Service Bulletin No: 34-005

Modification No: EC-12-0334, EC-12-0541

**NAVIGATION - FLIGHT ENVIRONMENT DATA  
MODIFICATION TO THE PITOT SYSTEM****1. Planning Information****A. Effectivity**

Disconnect the Plastic Tube Assembly  
Figure 1

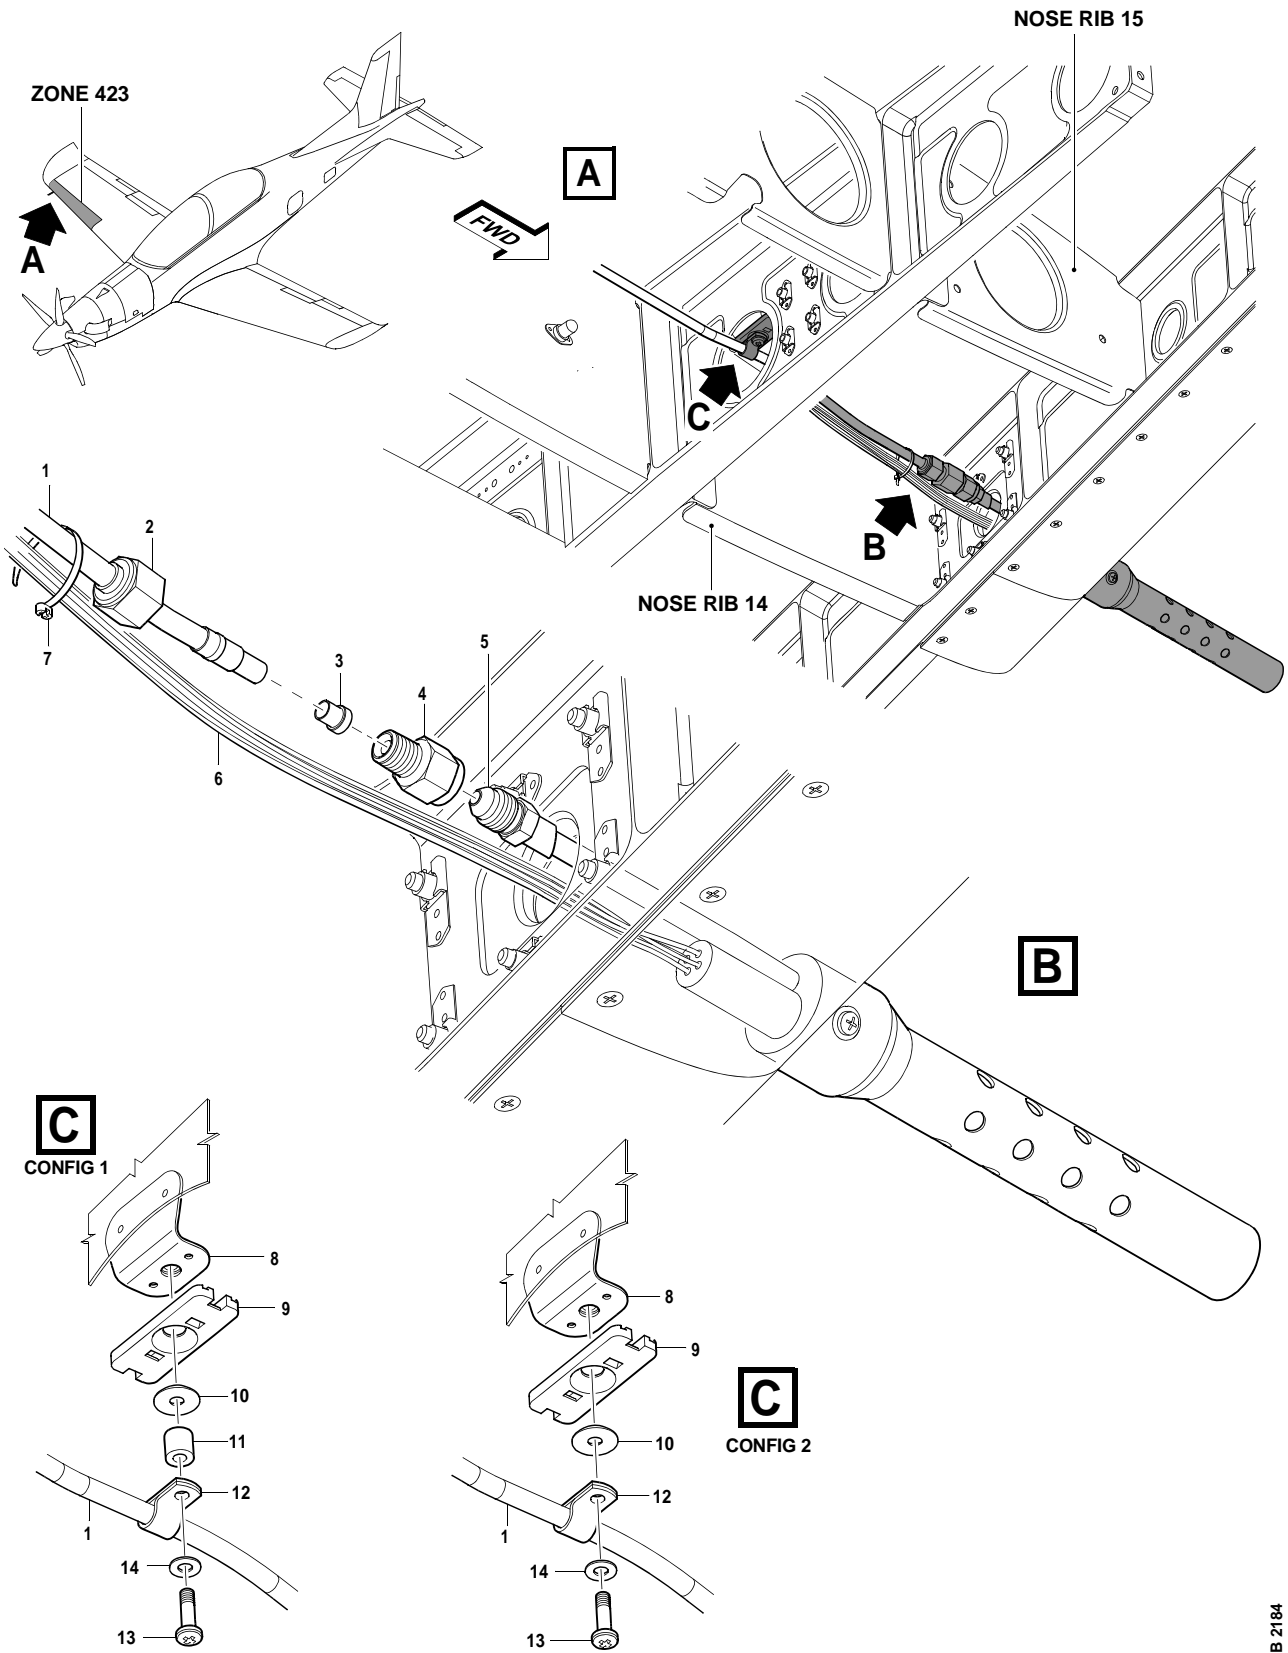
- (1) Disconnect the plastic tube assembly (Ref. Fig. 1)
  - (a) Cut and remove the cable ties (7) that attach the electrical wires (6) to the tube (1) between the pitot tube and the wing spar.
  - (b) Disconnect the nut (2) from the fitting (4).
  - (c) Disconnect the fitting (4) from the pitot tube (5).
  - (d) Remove, and discard, the insert (3), the fitting (4) and the nut (2).
  - (e) For Config 1 aircraft:
    - 1 Remove the screw (13), the washer (14), the bush (11), the special washer (10) and the attachment (9) from the angle (8).
    - 2 Remove the clamp (12) from the tube (1).
    - 3 Discard the washer (14) and the clamp (12). Keep the screw (13), the bush (11), the special washer (10) and the attachment (9).
  - (f) For Config 2 aircraft:
    - 1 Remove the screw (13), the washer (14), the special washer (10) and the attachment (9) from the angle (8).

- 2 Remove the clamp (12) from the tube (1).
        - 3 Discard the screw, (13,) the clamp (12) and the washer (14). Keep the special washer (10) and the attachment (9).
- (2) Make the holes in the main spar (Ref. Fig. 2):
  - (a) Remove the four screws (2).
  - (b) Use the string (or equivalent - local supply) and tie the two terminal blocks (1) clear of the work area.

Installation of the Template  
Figure 2

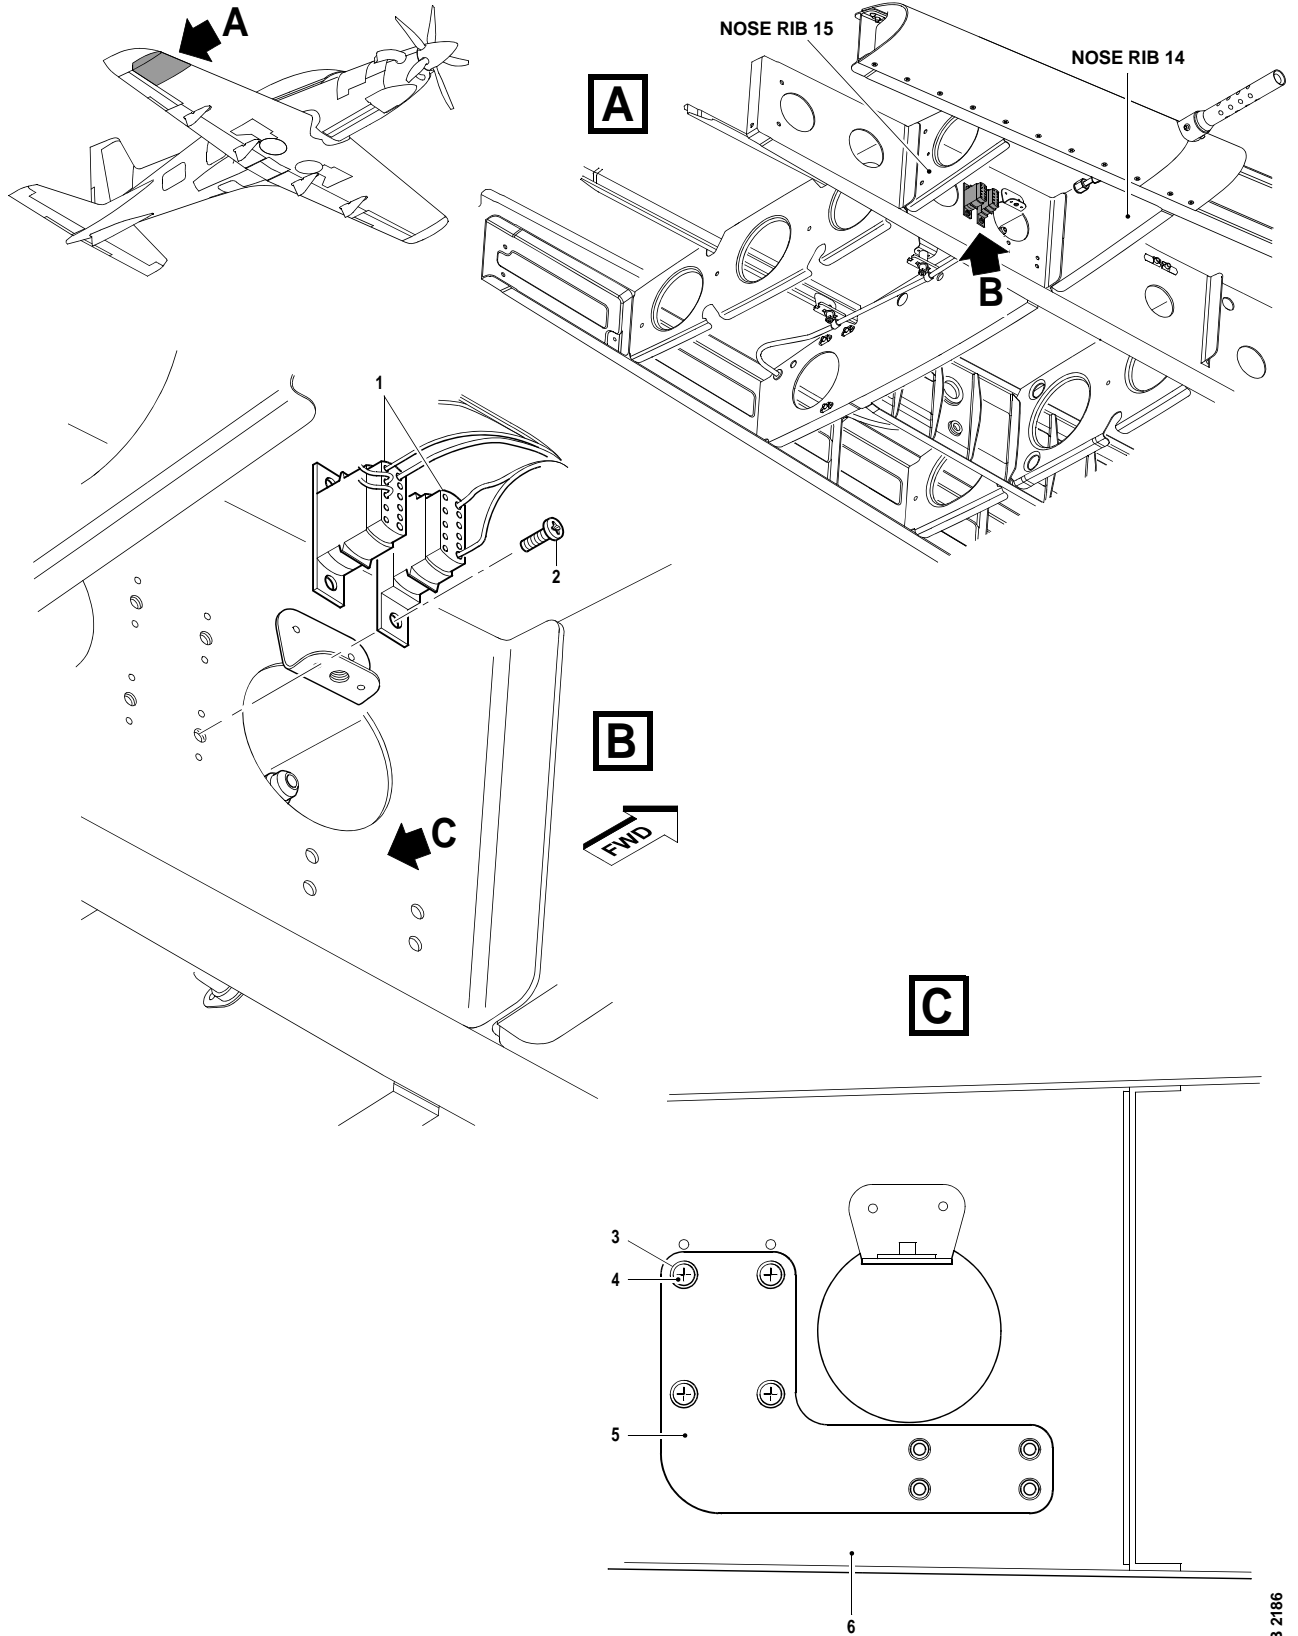
**NOTE:** This is to keep the strain from the cables of the terminal blocks (1).
  - (c) Put the hole template (5) (P/N 513.34.21.030) in position on the wing main spar (6).
  - (d) Use the screws (4) (P/N 935.63.11.066) and the washers (3) (P/N 938.77.61.011) to keep the hole template (5) (P/N 513.34.21.030) in position.

**NOTE:** Make sure that when you drill the four holes for the attachment angle (Fig 3, Item 29) (P/N 534.11.21.024), they do not go through the joggle in the structure. Loosen the screws (4) (P/N 935.63.11.066) and move the position of the template (5) (P/N 513.34.21.030) to make sure you do not drill through the joggle. Tighten the screws (4) (P/N 935.63.11.066).

- (e) Drill four 3.2 mm holes for the attachment angle (Fig 3, Item 29) (P/N 534.11.21.024).
  - (f) Remove:
    - The screws (4) (P/N 935.63.11.066)
    - The washers (3) (P/N 938.77.61.011)

- The hole template (5) (P/N 513.34.21.030).
  - (g) Use a 4.8 drill and make the four holes in the main spar (6) larger.
  - (h) Use the 5.1 reamer and make the four holes in the main spar (6) larger.

Install the Modified System Parts  
Figure 3

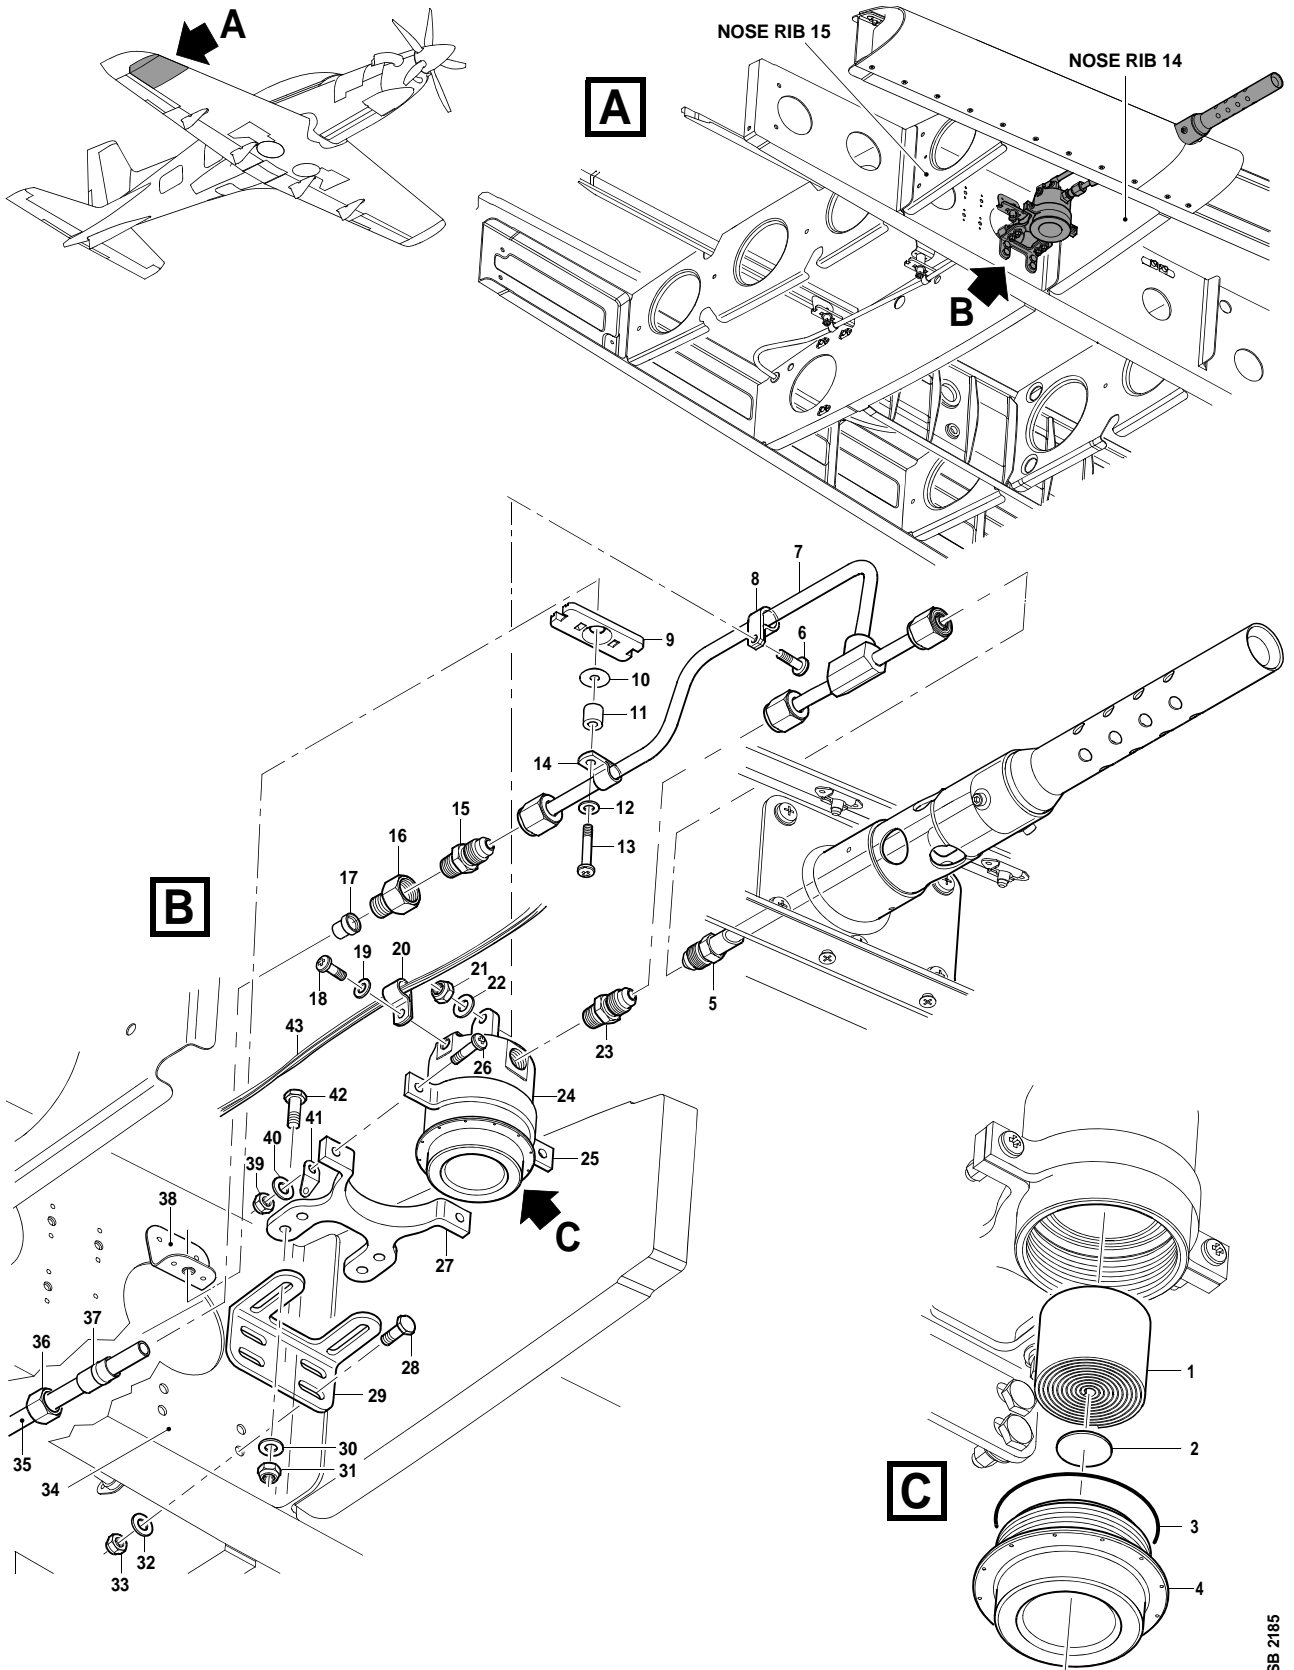
Introduction of an inertial water separator which prevents ingress of water into the pitot tubing in the wing.

Revision No. 1 of this Service Bulletin is issued to correct the size, and therefore, the part number of the screw and washer that attaches the clip (which holds the electrical wires) to the water container. New kits have been created to include these new parts.

- (3) Install the modified system parts (Ref. Fig. 3)
- (a) Put the packing (3) (P/N 946.91.26.130) in the groove on the tank cover assy (4) (P/N 534.11.21.037).

- (d) Install the tank cover assy (4) (P/N 534.11.21.037) in the water container (24) (P/N 534.11.21.021).
  - (e) Put the bracket (25) (P/N 534.11.21.029) and the bracket (27) (P/N 534.11.21.023) around the water container (24) (P/N 534.11.21.021) and loosely install:

- (ad) Connect the nut (36) (part of the fitting (P/N 946.01.17.101)) to the connector (16) (part of the fitting (P/N 946.01.17.101)).
- (ae) Put the clamp (20) (P/N 946.31.05.703) on the electrical wires (43) to the pitot tube.

- (af) Put the clamp (20) (P/N 946.31.05.703) against the water container (24) (P/N 534.11.21.021) and install the screw (18) (P/N 935.63.12.064) and the washer (19) (P/N 938.77.11.112).

- (1) Remove the screw (18) (P/N 935.63.11.062) and the washer (19) (P/N 938.77.11.111).
- (2) Make sure the clamp (20) (P/N 946.31.05.703) stays in position around the electrical wires.
- (3) Discard the screw (18) (P/N 935.63.11.062) and the washer (19) (P/N 938.77.11.111).
- (4) Put the clamp (20) (P/N 946.31.05.703) against the water container (24) (P/N 534.11.21.021) and install the new screw (18) (P/N 935.63.12.064) and the new washer (19) (P/N 938.77.11.112).
